UN R 46 impact test rig

▪ Background

The regard of UN R 46, two different interpretations of the diameter of sphere have occurred.

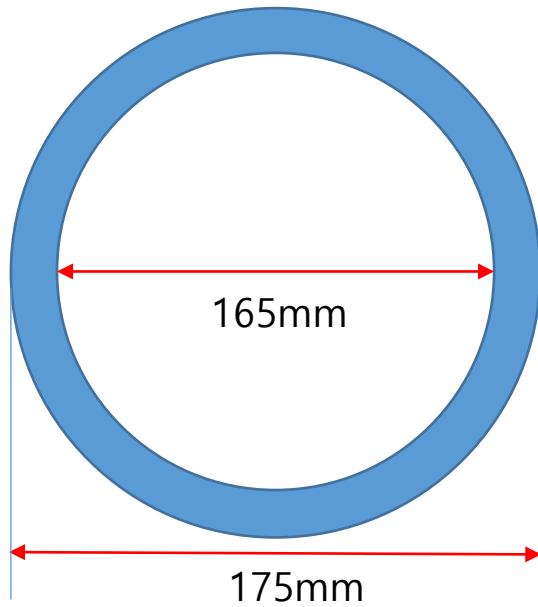
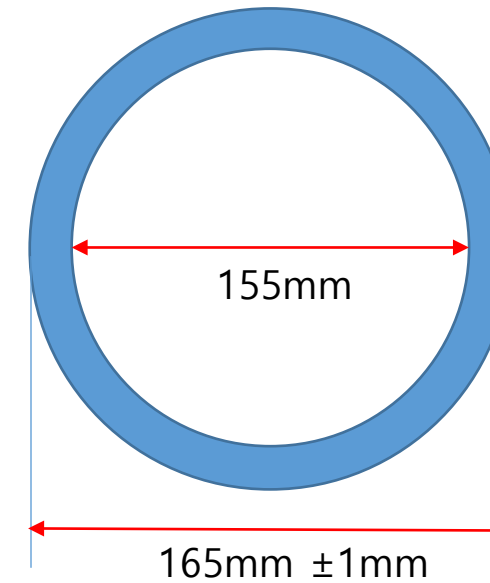
or

The end of the pendulum comprises a hammer formed by a rigid sphere with a diameter of 165 ± 1 mm having a 5 mm thick rubber covering of Shore A hardness 50.⁴

Other relevant regulations including an impactor, which are representing a head, are defining the geometric diameter value as 165mm
